LAKE PONTCHARTRAIN, L.A.
AND VICINITY
**LAKE PONTCHARTRAIN
HIGH LEVEL PLAN**

**DESIGN MEMORANDUM NO. 20
GENERAL DESIGN**

**ORLEANS PARISH
JEFFERSON PARISH
17th. St. Outfall Canal
(Metairie Relief)**

CELMV-ED-PG (CELMN-ED-SP/15 May 90) (1105-2-10c) 3d End
Mr. Eckenrod/ts/5925
SUBJECT: Lake Pontchartrain, Louisiana and Vicinity, High Level Plan, Design
Memorandum No. 20 - General Design, 17th Street Outfall Canal

m. Comment m. Plates 121 through 124. Concur. Revised plates 121 through 124 are enclosed as Encl 3.

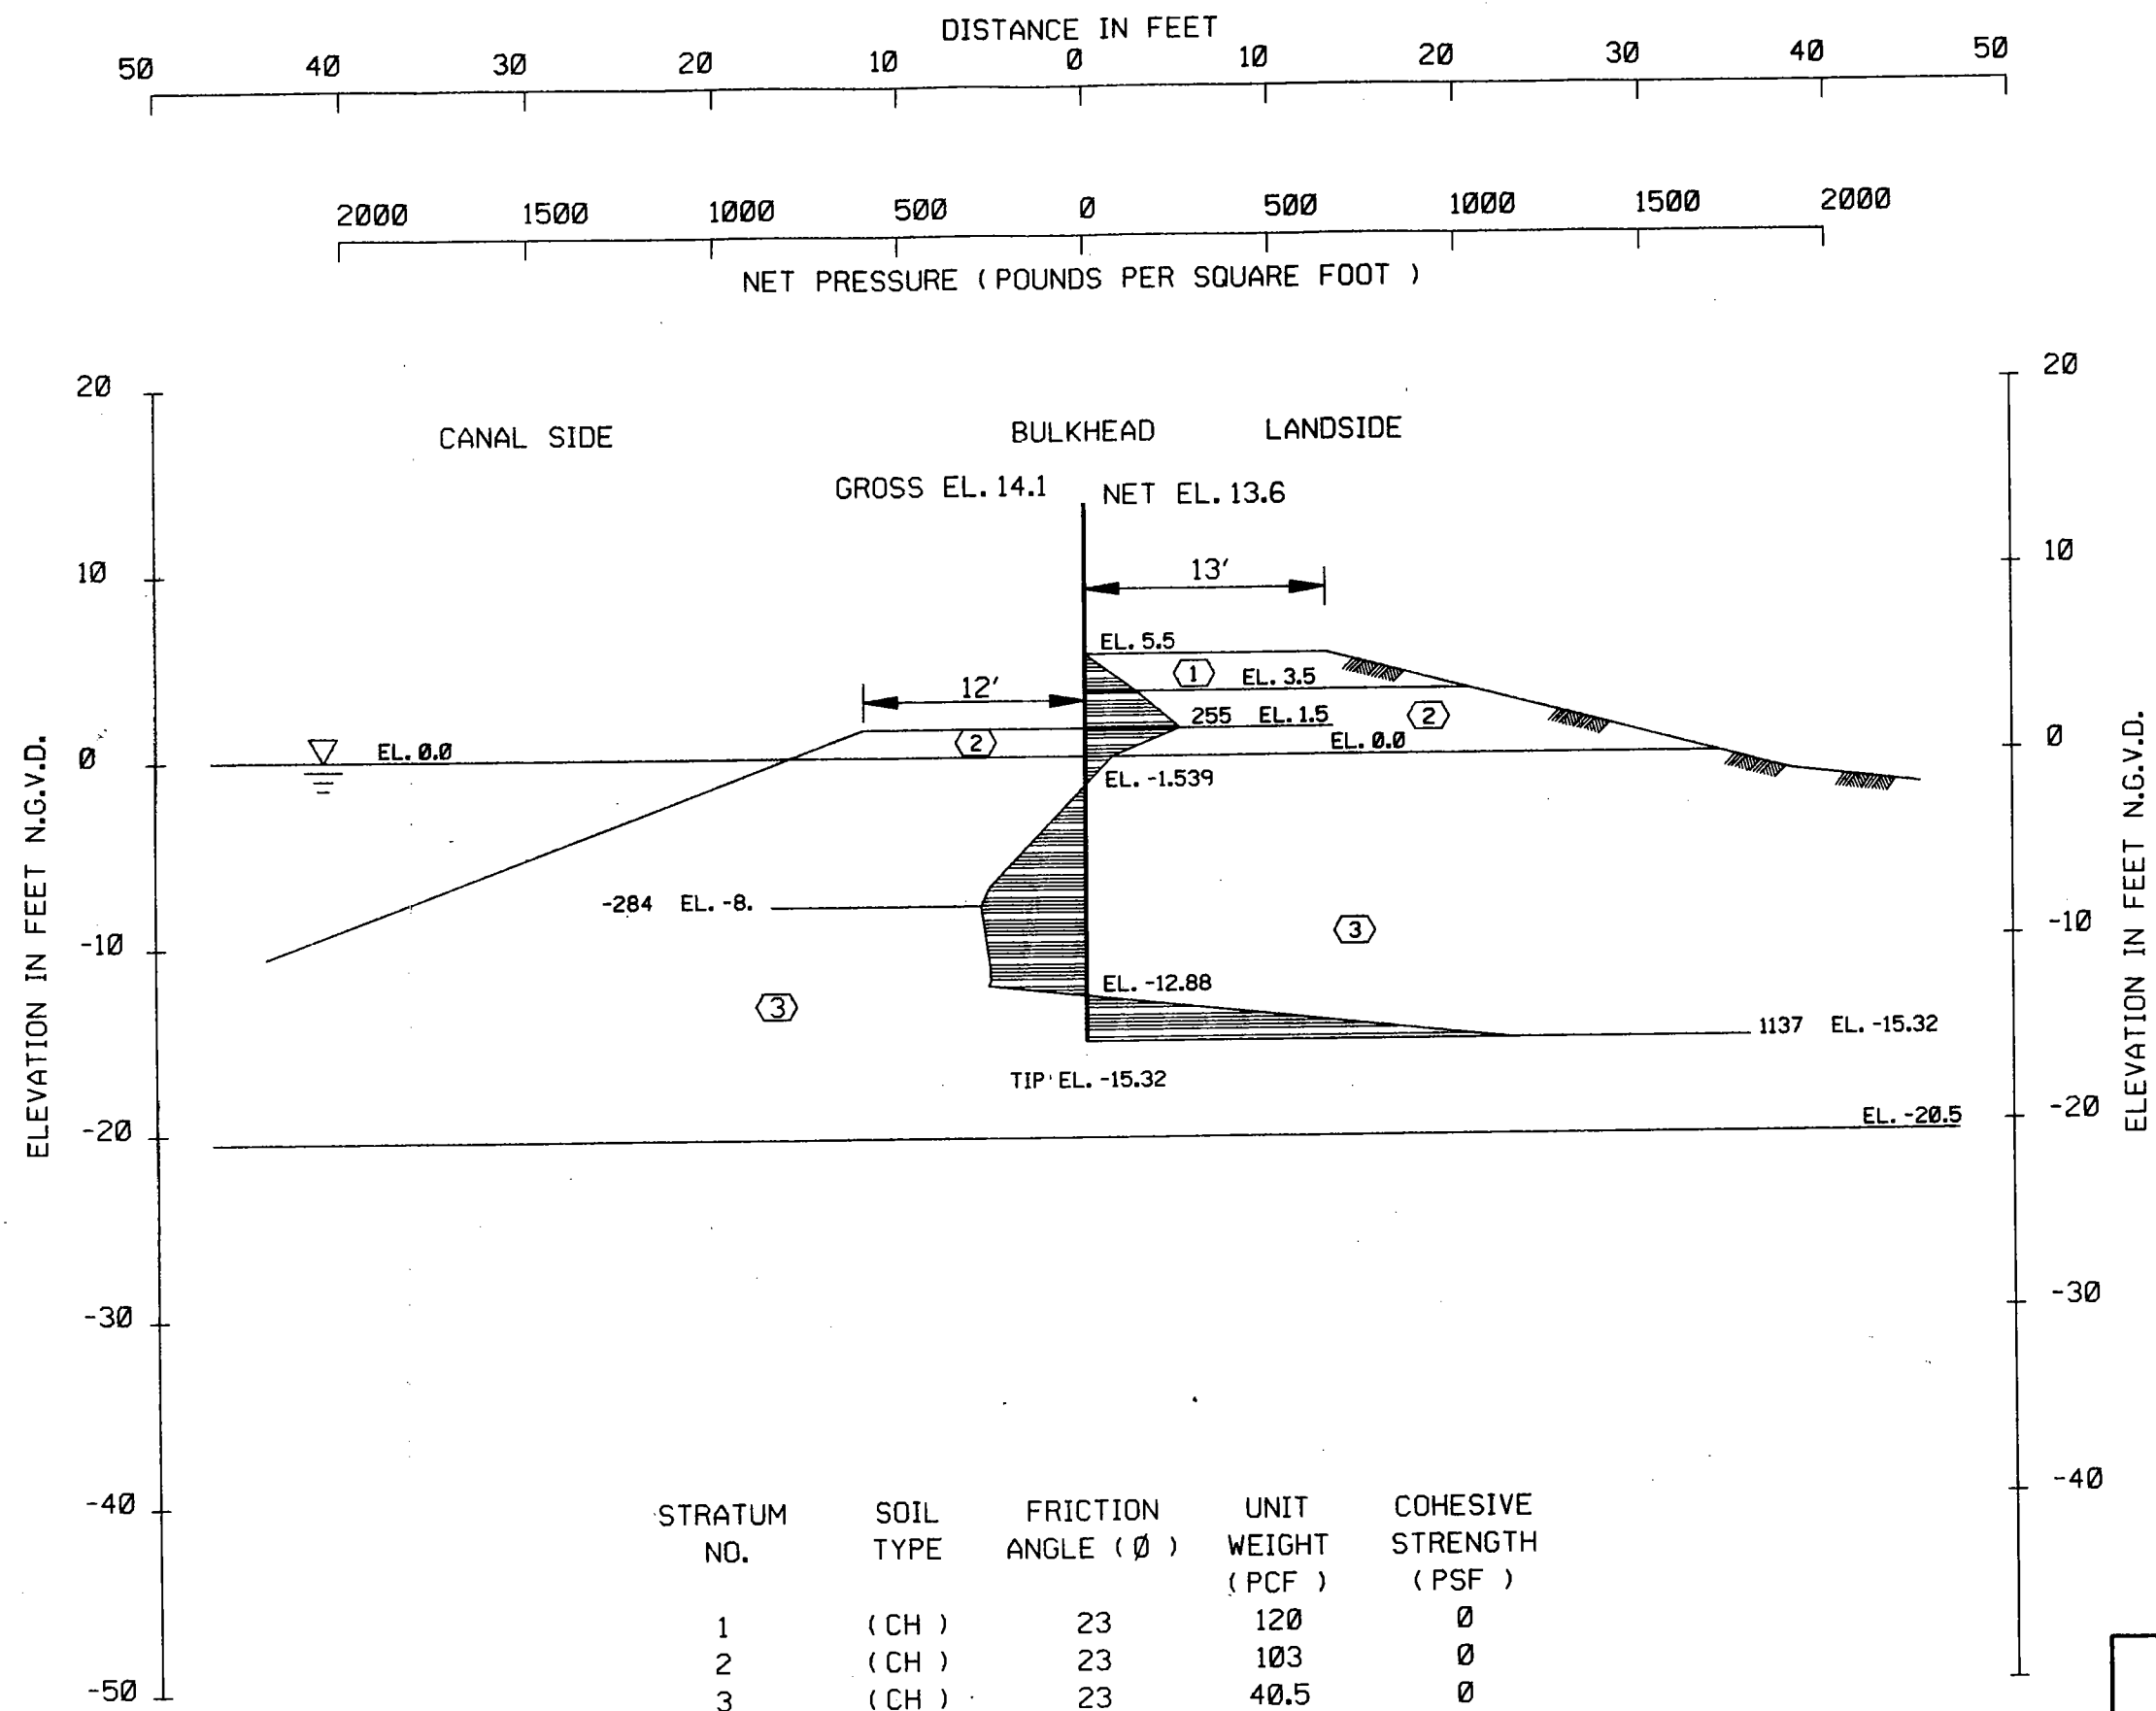
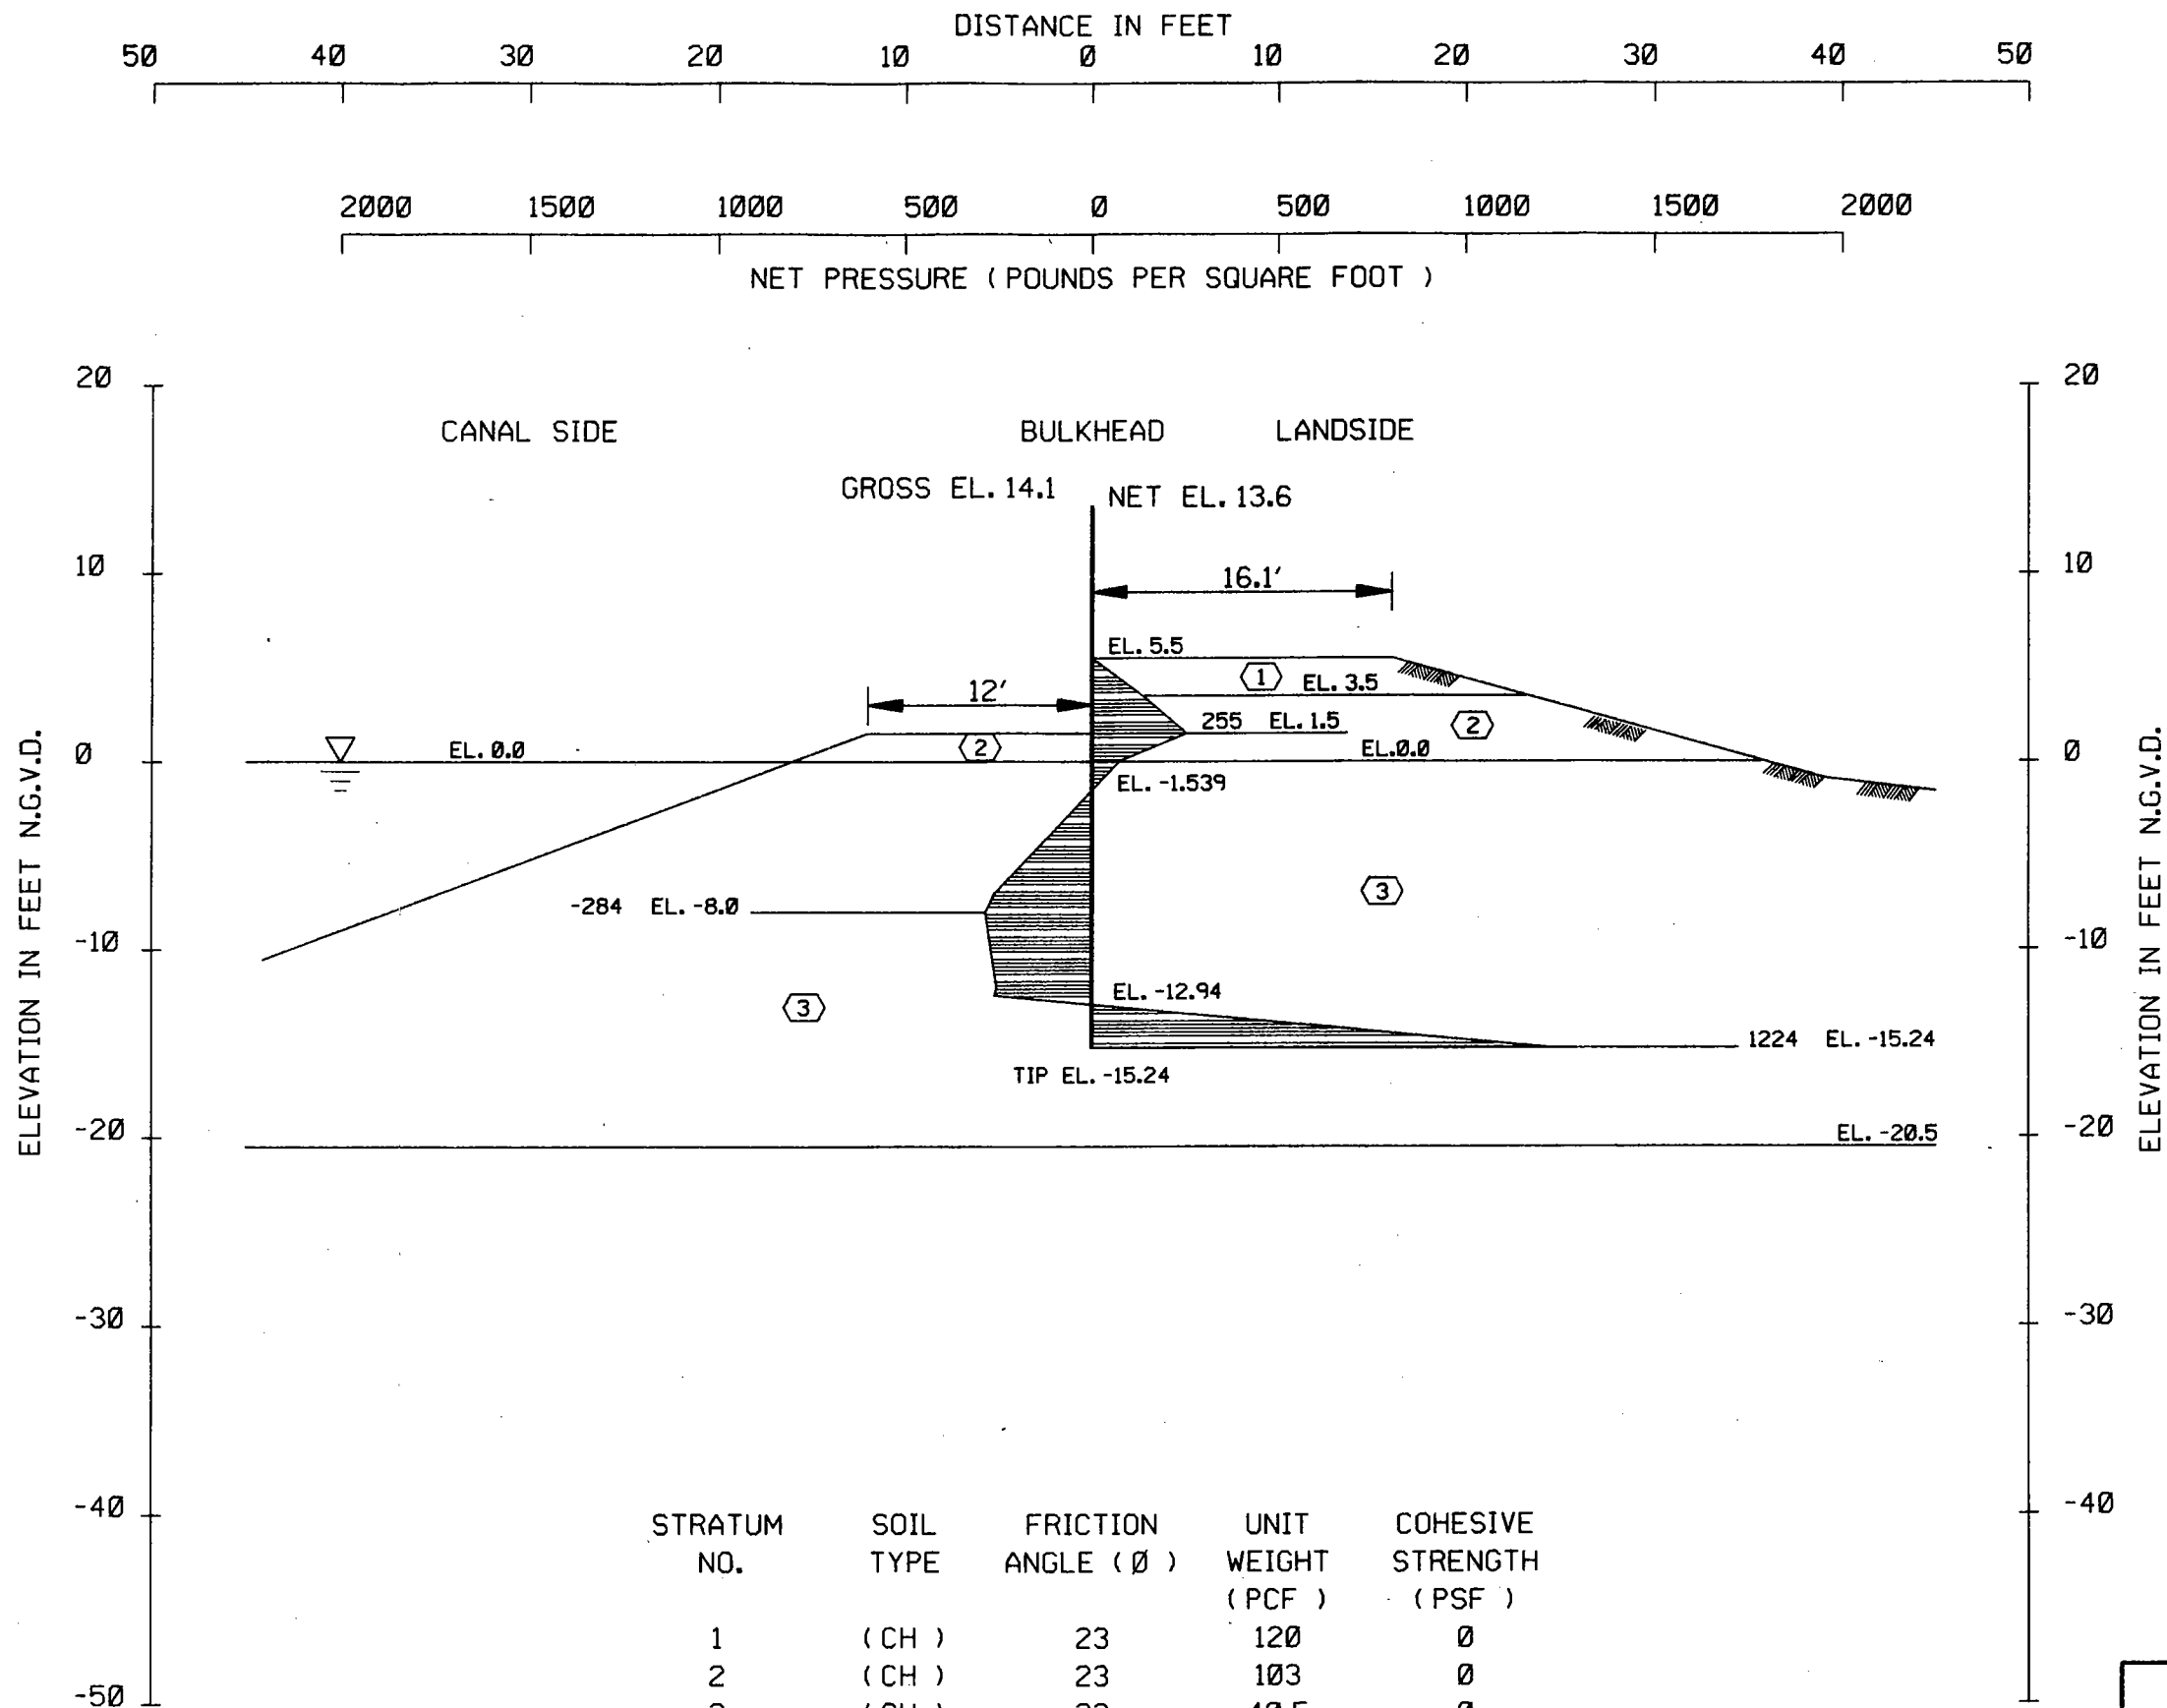
d. Para 29c. Also refer to the tied back and braced wall analyses on Plates 121-124. These analyses are based on the "Q" case soil strengths, a canal level at el -5.0, and a factor of safety of 1.5. Since these sheet pile bulkheads permanently retain soil, they should also be analyzed using "S" soil strengths, a factor of safety of 1.5, and at the normal canal level of el 0.0.

m. Plates 121 through 124. The walls shown on these plates should be evaluated for the anchor forces and resulting stresses on the anchors and the sheet piling should be checked using the conditions shown except change the water level on the canal side to el 0.0 NGVD and use soil properties for the 'S' case and a F.S. = 1.5.

d. Comment d. Para. 29c. The analyses presented were for the Q-CASE soil strengths, a canal level at EL. -5.0 and a factor of safety of 1.5. For plates 121, 122, and 124 the actual design (completed before Dec 87) was controlled by the S-CASE, F.S. = 1.5, and canal level at EL -5.0. The design on plate 123 (completed after Dec 87) was based on the S-CASE F.S. = 1.2 with canal level at EL -5.0; S-CASE F.S. = 1.5 with canal level at EL 0.0; or the 3:1 penetration to head ratio. All the braced walls and tieback walls have been constructed. The tip penetrations shown on plates 122-124 are deeper than the minimum required tip penetration (Encl 3). Intermediate tip penetrations were used to reduce the anchor forces.
